CITY OF TAYLOR, TEXAS

PLANNING AND ZONING COMMISSION MEETING

March 14, 2023, 6:00 P.M.

City of Taylor
PZ-2022-1494
Mule Loop Townhomes
Subdivision Improvement Plans
Staff Report

FINAL PLAT ESTABLISHING
CASTLEWOOD SOUTH PHASE 1
SUBDIVISION

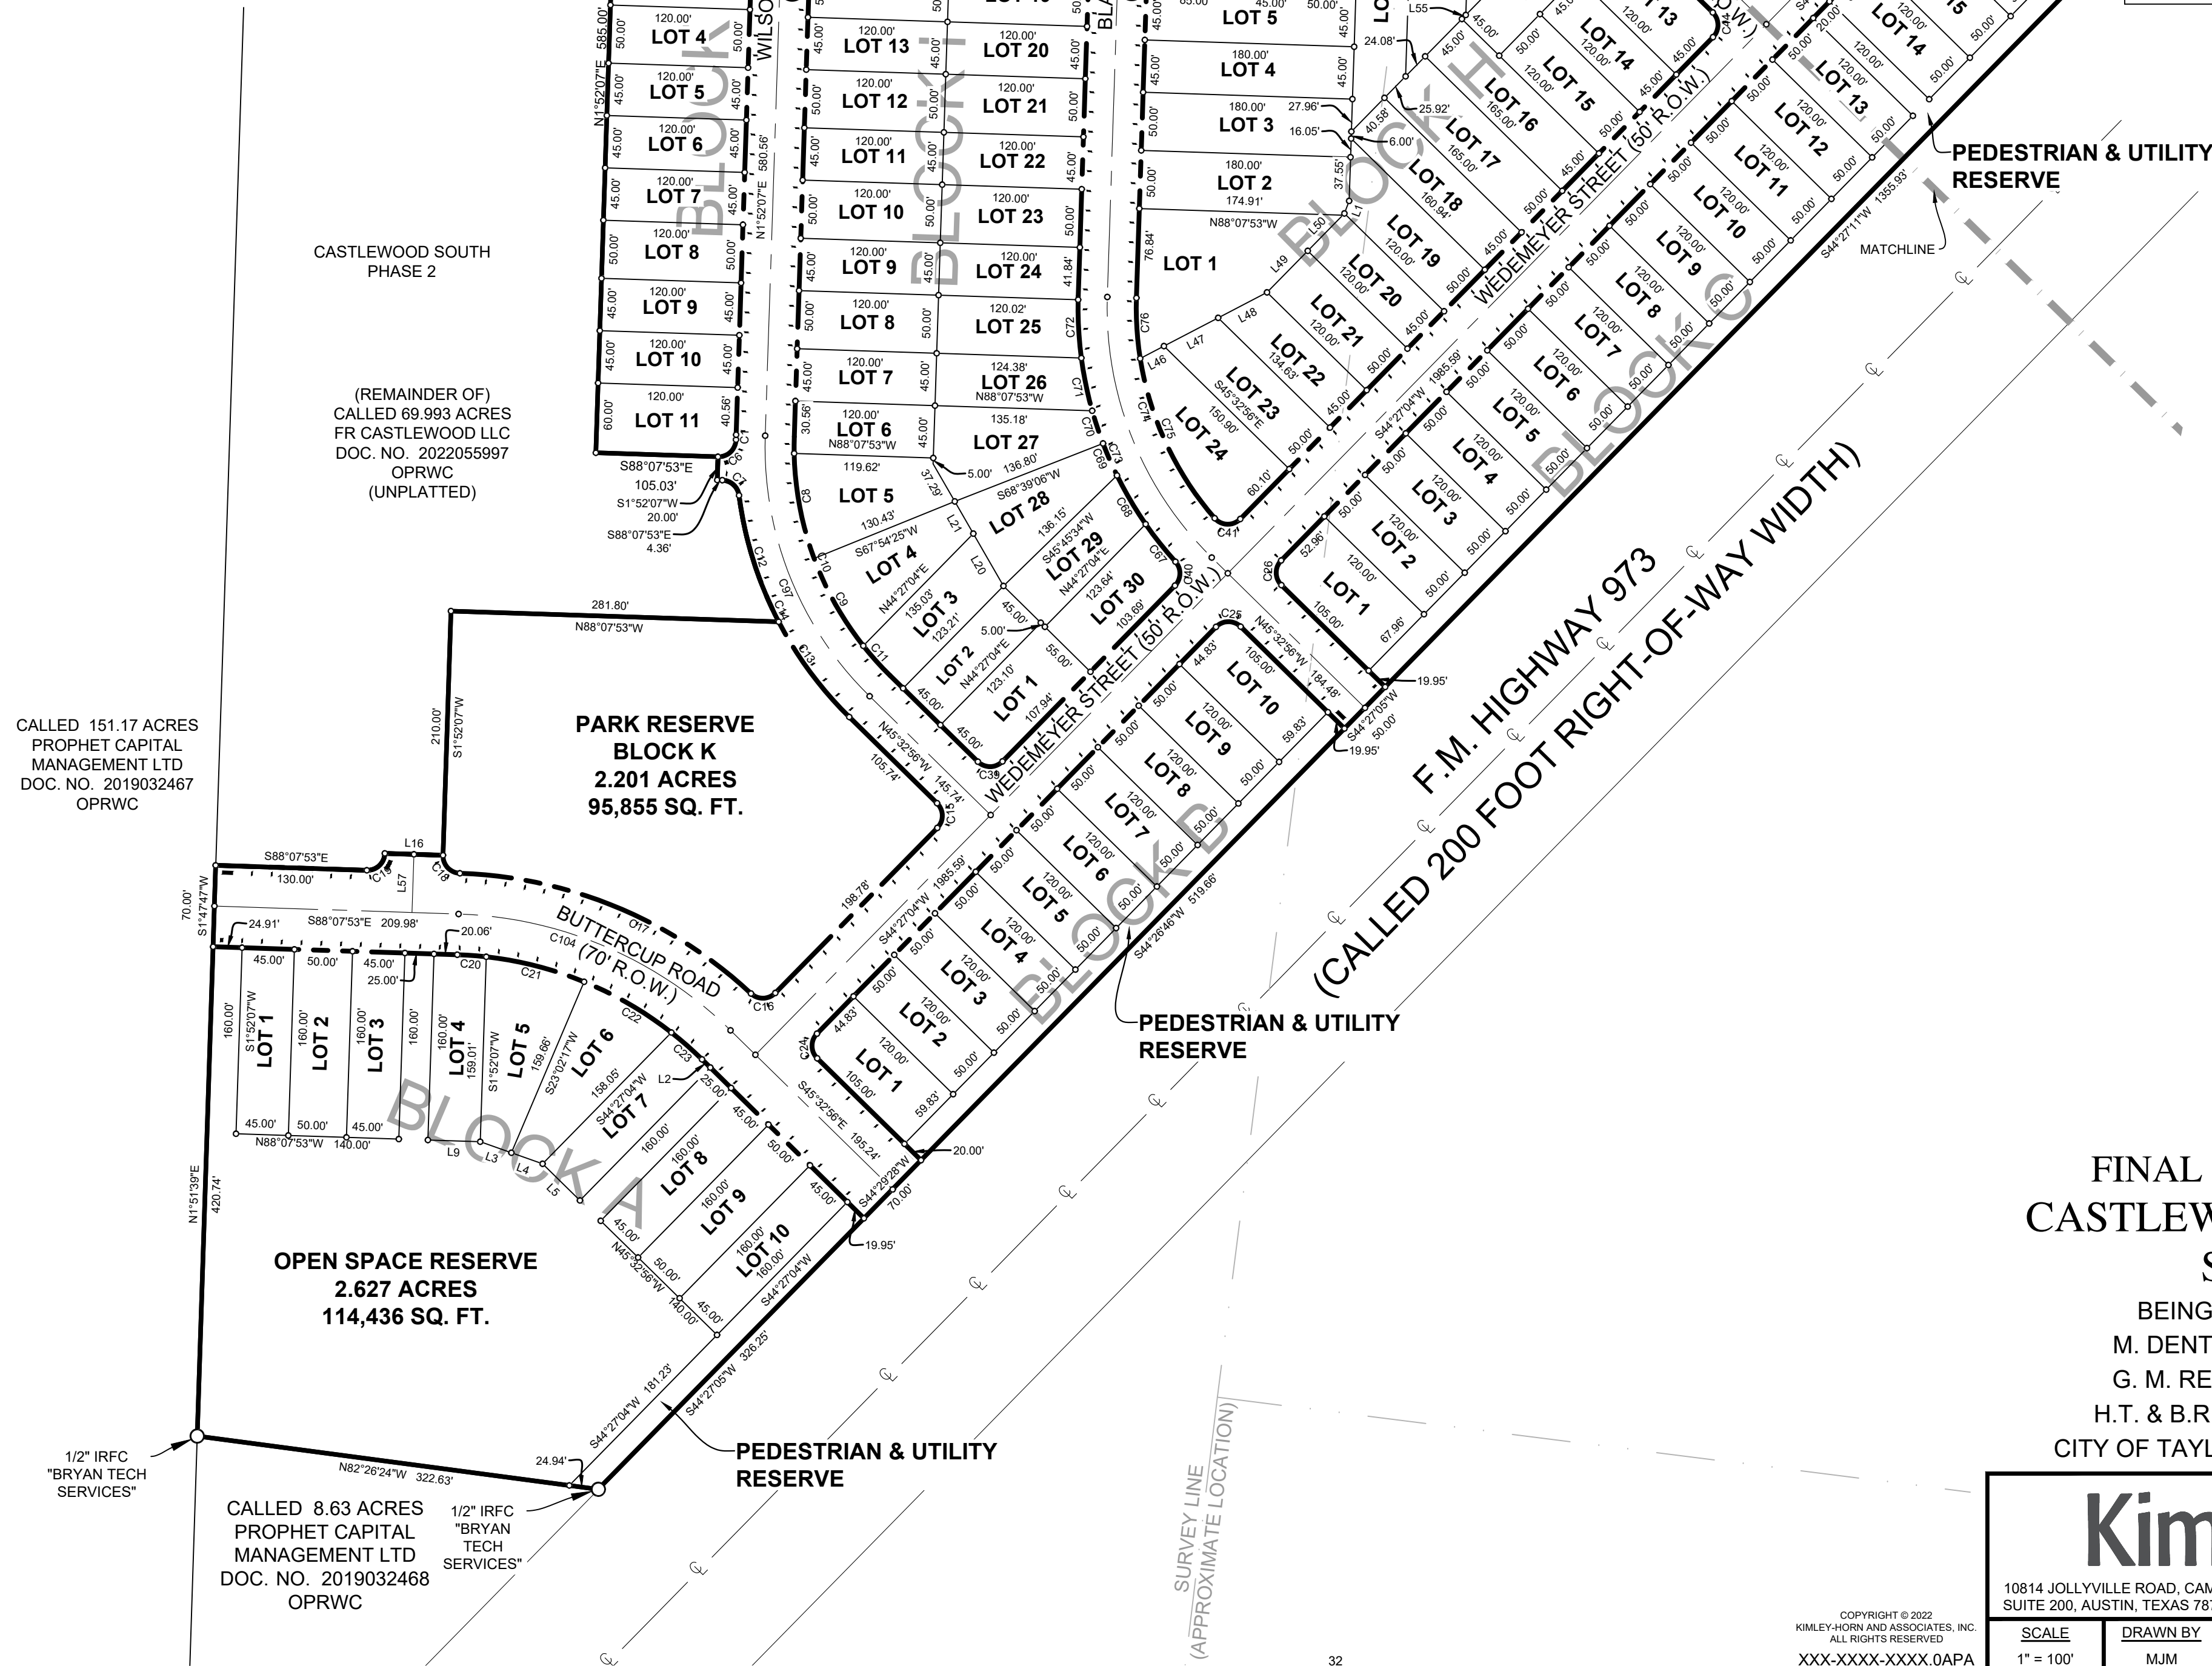
1. Sheet 1-4 – Remove “Establishing” from the Title – this is not typical.
2. Sheet 1-4 – Provide the City’s project number: PZ-2023-1626.
3. Sheet 1 – Provide a Revision Table.

4. Sheet 1 – Include a count for the number of Blocks (ex: 8 Blocks, Block A-H).
5. Sheet 1-2 – Ensure block identifiers are legible. Ex – Block J is not clear and other text overlaps.

6. Sheet 1 – Provide a location map to scale (1:1,000) with cross streets (FM 973 and Wesley Miller for existing ROW references).
7. Sheet 1 – Because the plat is multiple pages it may be easier to capture all the typical required information (“Subdivision Information”) on a Cover Page and then leave the remaining pages to purely identify the subdivision layout and boundaries etc.

8. Sheet 1 – Revise the lot count for Single Family lots. Counted 154.
9. Sheet 1 – Identify a Block designation for the Open Space Reserve (~2.627 acres).

10. Sheet 1 – The preliminary plat calls out drainage easements off of Buttercup Rd. leading back into the “Open Space Reserve” – these easements should be reflected the same or similar to how they are shown on the preliminary plat.

11. Sheet 1 – The preliminary Plat calls out a 10’ Pedestrian Sidewalk easements within Park Reserve 1 (Block K). Please ensure that this information is translated onto the Final Plat.

12. Sheet 1 -2 – Please ensure that the acreage and width of the Pedestrian and Utility Reserve along FM 973 identifies acreage and width like it is shown on the Preliminary Plat. Additionally, this area should be hatched similarly as it was shown on the preliminary plat to more clearly define the area being considered as the pedestrian and utility reserve.

13. Sheet 1-2 – Ensure that a 10’ Public Utility Easement is dedicated along all street frontages. This verbiage needs to be within a Plat Note as well as shown on the plat pages.

14. Sheet 2 - The cul-de-sac along Rodgers Road should be identified as a temporary cul-de-sac to ultimately become a 90-degree intersection with Wesley Miller (as shown in the preliminary plat) in the future.

15. Sheet 3 – I see that Block D is shown to have two lots. These lots need to be called out on the plat. I am unclear on where Lot 2 consisting of 7,608 square feet exists.

16. Sheet 3 – Block E also identifies a Lot 1 which needs to be called out on the Plat (Block E, Lot 1).
17. Sheet 3 – Block K also identifies a Lot 1 which needs to be called out on the Plat (Block K, Lot 1).

18. Sheet 4 – Owner signature block states “and do hereby state that there **are** lien holders on that certain tract of land” – if this is true, please provide a Lien Holder(s) signature block or revise text.

19. Sheet 4 – Surveyor’s signature block states unique language. Please revise to use the language provided here: I, <surveyor’s name> , Registered Professional Land Surveyor in the State of Texas, do hereby certify that this plat is true and correctly made from an actual survey made on the ground of the property legally described hereon, and that there are no apparent discrepancies, conflicts, overlapping of improvements, visible utility lines or roads in place, except as shown on the accompanying plat, and that the corner monuments shown thereon were properly placed under my supervision in accordance with the subdivision regulations of the City of Taylor, Texas.

20. Sheet 4 – Shift the County Clerk’s signature block to beneath the P&Z signature block.
21. Sheet 4 – Provide a Director of Development Services signature block.

22. Sheet 4 – There appears to be a Notary signature block in the top right-hand corner and it is unclear what that is associated with. Please revise or remove.

23. Sheet 4 – Revise Planned Development Ordinance to most recent – 2021-07. Revise all instances.
24. Sheet 4 – Note # 11 – This should allude to the requirements for sidewalks within the Planned Development. It also does not match what is shown in the legend which identifies all sidewalks to be 6’.

25. Sheet 4 – Refer to the Preliminary Plat to incorporate any missing notes (as applicable). For instance, there should be a plat note on the final plat that gives information as to what datum was used i.e., NAD 83 Texas Central Zone etc.

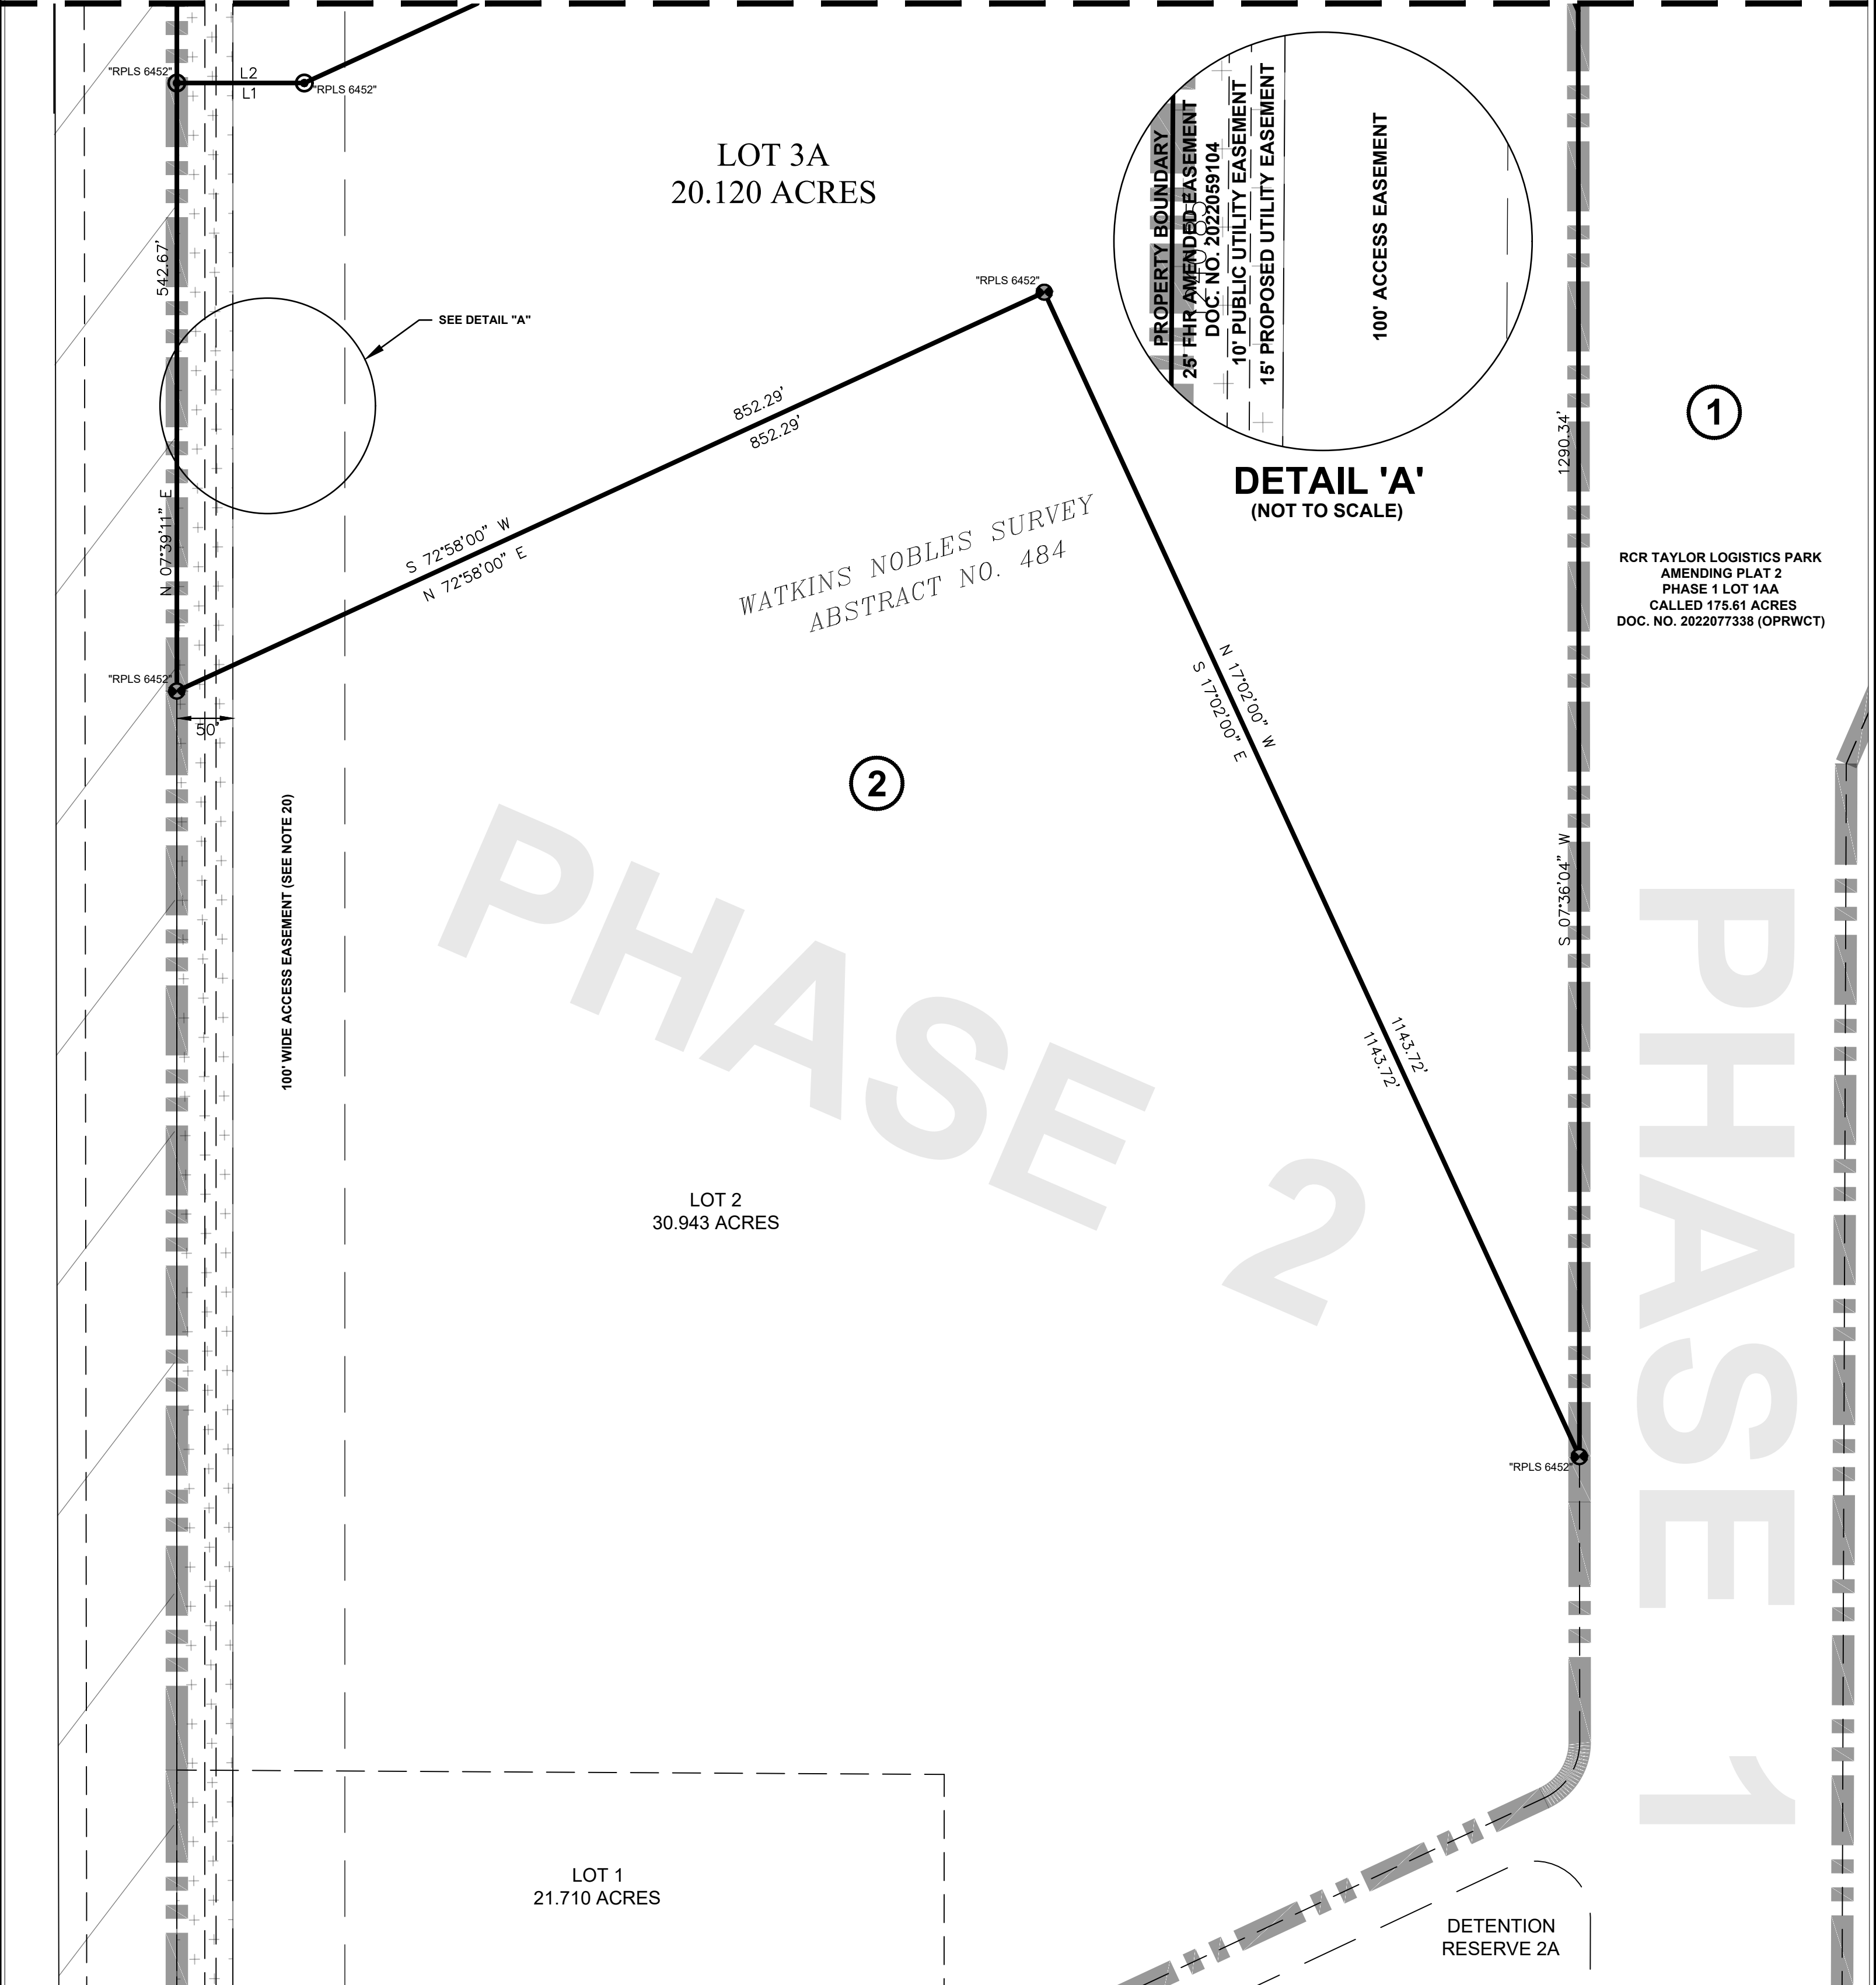
1. Sheet 1 – Provide City of Taylor project number PZ-2023-1628.
2. Sheet 1 – The first page of the plat should provide the following information:
 - i. Owner's Name,

3. Sheet 1 – Revise the location map to a 1:1,000 or 1:2,000 scale and only include the boundaries of the subject property being replatted. Ensure that all adjacent street names are present and legible.

4. Sheet 1 – The legal description should relate back to the parent plat that the replat is being deviated from (RCR Phase Two Minor Plat). The instrument number for the parent plat should be 2022113235. The replat legal description should relate back to the Minor Plat and its recording information only.

5. Sheet 1 & 2 – Ensure to identify all adjoining properties (shown in dashed line), include property lines labeled names of recorded subdivisions (i.e., Block 2, Lots 1 & 2).

6. Sheet 2 – The thick dashed (dash dot dot dash) line over the parcel lines that goes beyond lot 3A should be removed to not cause confusion with what is being considered as part of this replat.

7. Sheet 3 – Provide a Director of Development Services signature block.
8. Sheet 3 – Plat note #9 can be removed if it was determined in Plat Note #6 that no part of the subject property lies within the floodplain.

9. Sheet 3 – Revise Note #17 references to Minor Plat.
10. Sheet 3 – Note 22 "This subdivision is subject to all general notes and restrictions appears on the plat of RCR Taylor Logistics Park, Phase 2, Recorded as document #2022113235 of the Plat Records of Williamson County, Texas – please ensure that this document references the parent plat.

11. Sheet 3 – Include a plat note that references utility providers: Utility providers for this development are Water: _____, Wastewater/Septic: _____, and Electric: _____.
